The following changes in the tender documents are effective immediately. This addendum will form part of the contract documents.

Project title/Titre du projet  
**MATSQUI COMPLEX**  
**33344 KING ROAD**  
**ABBOTSFORD, B.C.**

**INTERNAL LIGHTING UPGRADE TO LED**

Drawing title/Titre du dessin  
**MATSQUI INSTITUTION**  
**SITE PLAN**

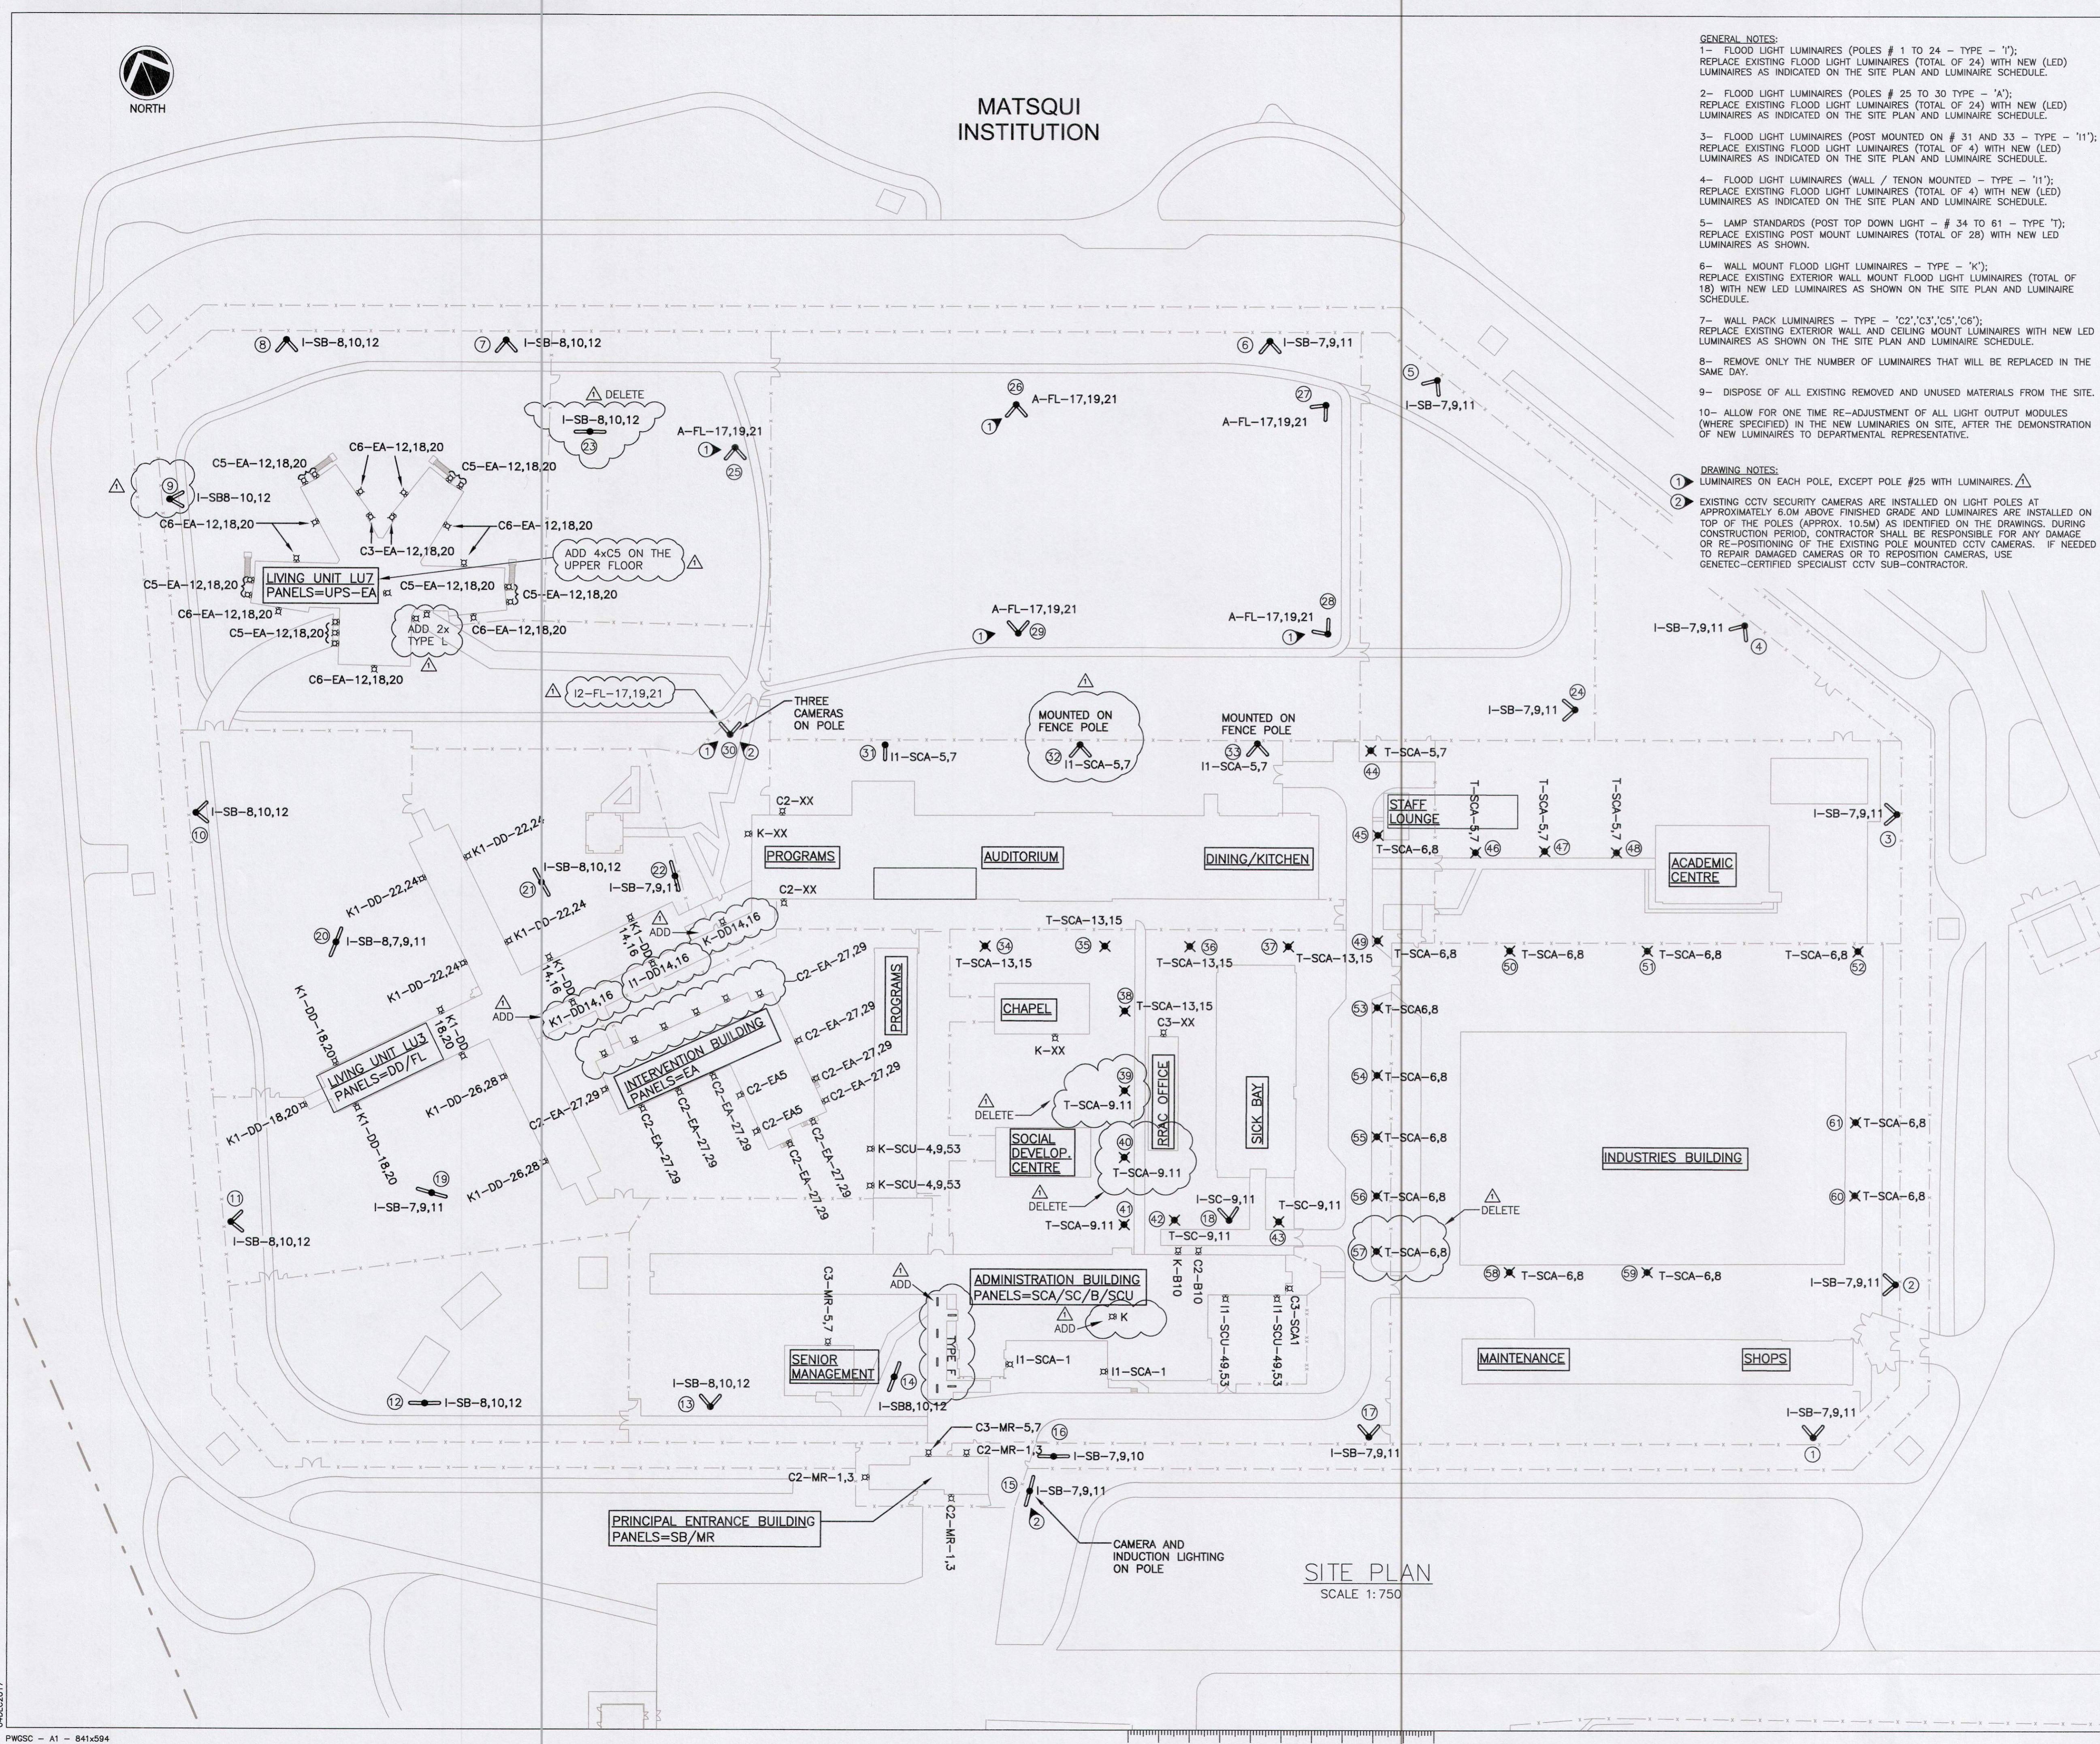
- .1 Drawing No. E-2 – MATSQUI INSTITUTION – Site Plan**
- (40) **Replace:** Drawing Note # 1 with new note to read:  
**“(4) Luminaires on each pole except pole # 25 with (5) luminaires.”**
- (41) **Replace:** Existing Type ‘F’ luminaires (total of 6) under the walkway cover in front of the Administration Building. Extend existing branch circuit wiring between the luminaires as required.
- (42) **Delete:** Pole # 23 with Type ‘I’ luminaires.
- (43) **Change:** single head luminaire to double head luminaire on Pole # 9 and # 32.
- (44) **Add:** Type ‘C5’ luminaires (total of 4) on the upper level of Living Unit – LU-7.
- (45) **Add:** Type ‘L1’ luminaires (total of 2) at the entrance of Building LU-7.
- (46) **Change:** Luminaire type from Type ‘A’ to Type ‘I2’ on Pole # 30.
- (47) **Add:** Type ‘K1’ (total of 1) and Type ‘I1’ (total of 1) luminaires on the Building LU-3.
-

- (48) **Add: Type 'K' luminaire (total of 1) on the side of walkway of Living Unit - 3 – yoke mounted.**
- (49) **Add: Type 'K' (total of 1) luminaire on the Administration Building.**
- (50) **Delete: Type 'T' luminaires (total of 3) – Poles # 40; #42 and #57.**
- (51) **Change: Type 'K' luminaires (total of 14) to Type 'K1' on Living Unit – 3.**

**MATSQUI INSTITUTION  
 LUMINAIRE SCHEDULE**

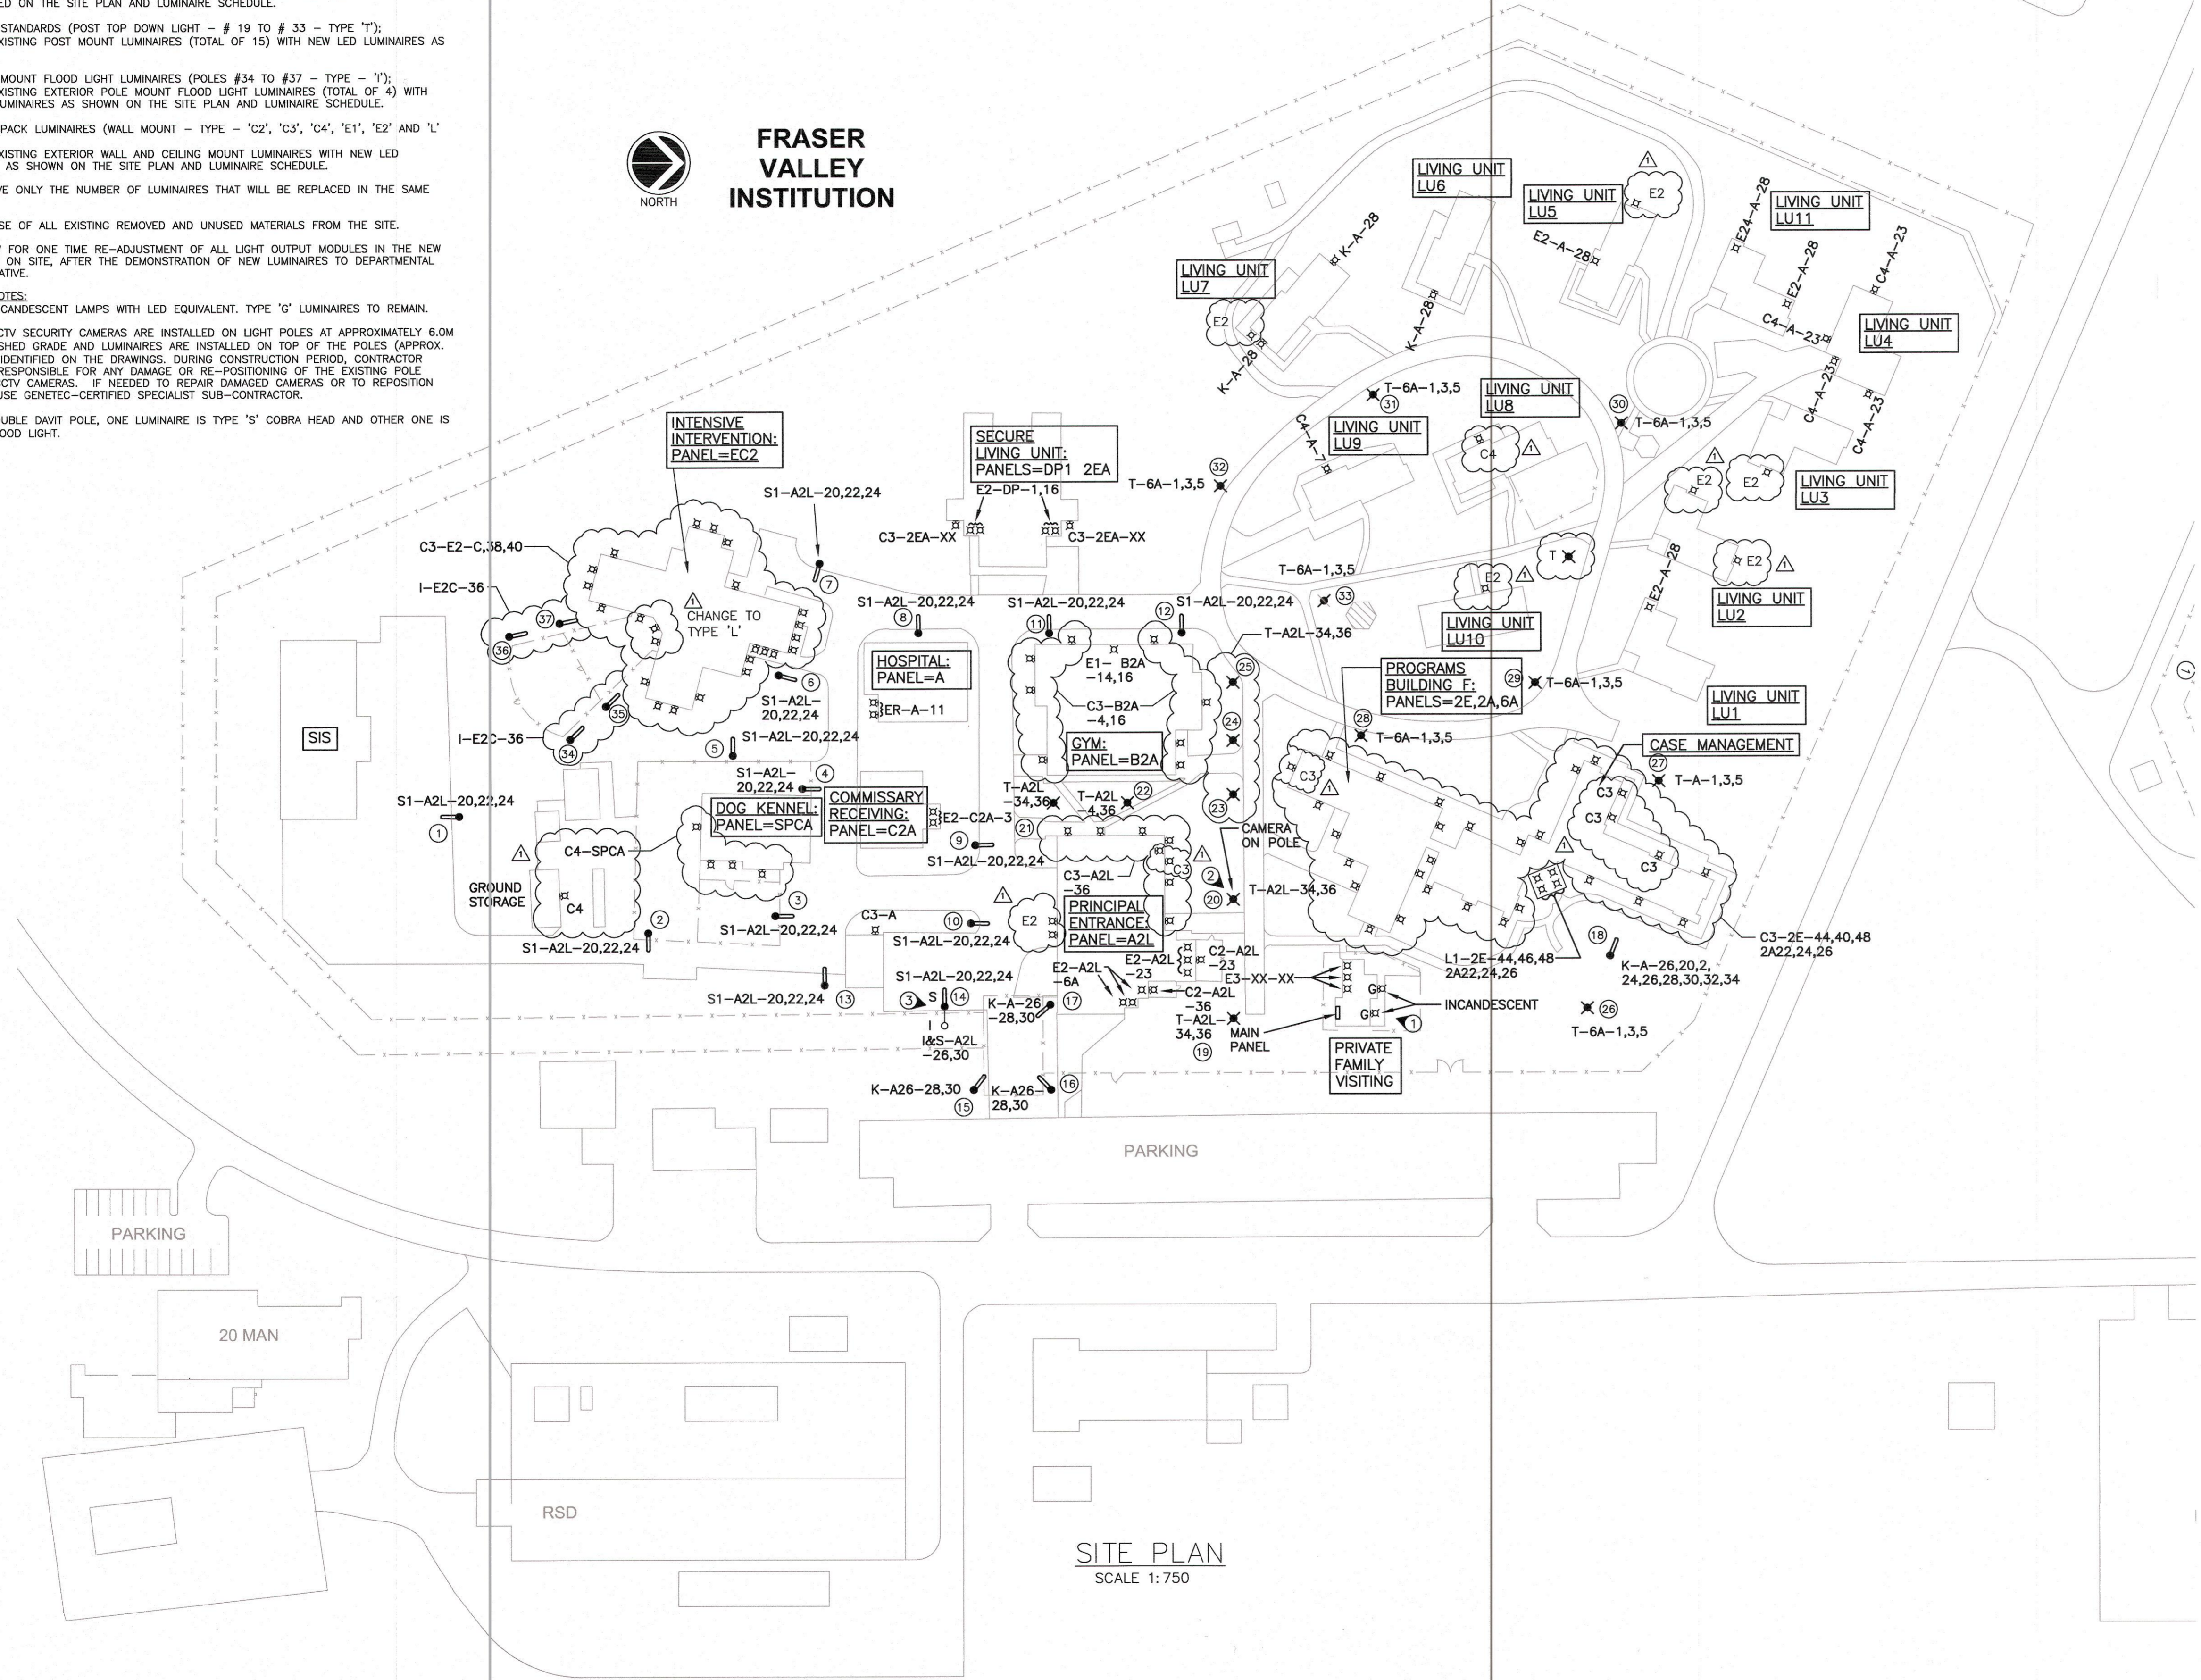
Luminaire Schedule – Living Unit 3;

- (52) **Revise: Type 'K' Luminaire to Type 'K1' (total of 14)**
- (53) **Revise mounting of: Type 'A' Luminaire to read: Yoke**
- (54) **Add: Type 'I1' luminaire (total of 1) – yoke mounted.**
- (55) **Add: Type 'K' luminaire (total of 1) – yoke mounted.**

Luminaire Schedule – Living Unit 7;

- (56) **Revise quantity of: Type 'C5' luminaire luminaire from (14) to (19).**
- (57) **Add: Type 'L' luminaire (total of 2)**

Luminaire Schedule – Administration Building;

- (58) **Revise quantity of: Type 'T' luminaire luminaire from (28) to (25).**
- (59) **Add : Type 'F' luminaires (total of 6).**
- (60) **Revise quantity of: Type 'K' luminaire from (1) to (2).**

Luminaire Schedule – Principal Entrance Building;

- (61) **Revise quantity of: Type 'I' luminaire from (47) to (46).**
